Safety recommendation: AIC 19-R17/18-1004

Addressed to: Federal Aviation Administration

Investigation link: AIC 18-1004

Figure 2. Mode 1 Sink Rate Alert Curves with DO-367 "Must Not Alert (Warning)" requirement¹⁰

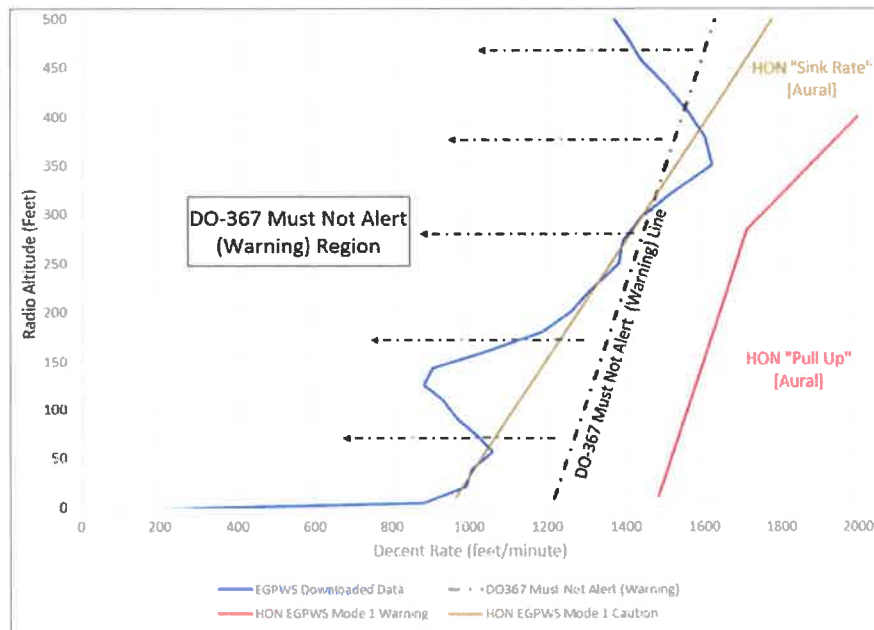
Furthermore, the minimum operational standards set out in DO-367 (MOPS) as depicted in **Figure 1** below shows the DO-367 'Must Not Alert' (Warning) Region, plotted against the Honeywell EGPWS Mode 1 Alerting Envelope. It is precisely in this region, at very low altitude and excessively high rate of descent that PXE was flown.

'it is virtually impossible for Honeywell to develop an alerting scheme that would result in a 'PULL UP' aural (Warning envelope) without violating the MOPS standards set forth in DO-367.'

The AIC Human Factors investigation determined that an attention-getting hard aural 'WARNING' alert, or a **flashing** visual '**PULL UP**' rather than a steady '**PULL UP**' caution on the PFDs, could have significantly driven the pilots to react positively and decisively, given the severity and significance of a hard warning (see footnote 7 on page 2). It could be the last line of defense for any flight crew who may unknowingly or inadvertently get in a similar fixated situation.

The PNG Accident Investigation Commission recommends that the Federal Aviation Administration should re-evaluate TSO's 151b and 151d and DO-367 related to EGPWS warnings and cautions, and ensure that the Honeywell EGPWS MK V Computer provides a **timely warning** in the form of a continuous **flashing** visual display of '**PULL UP**' at the bottom of the Primary Flight Displays, as an absolute minimum standard. A **flashing** visual display '**PULL UP**' warning, accompanying an aural 'SINK RATE', would require immediate action from the flight crew when encountering an excessive Rate of Descent at very low Radio Altitude, similar to that flown by the crew of P2-PXE.
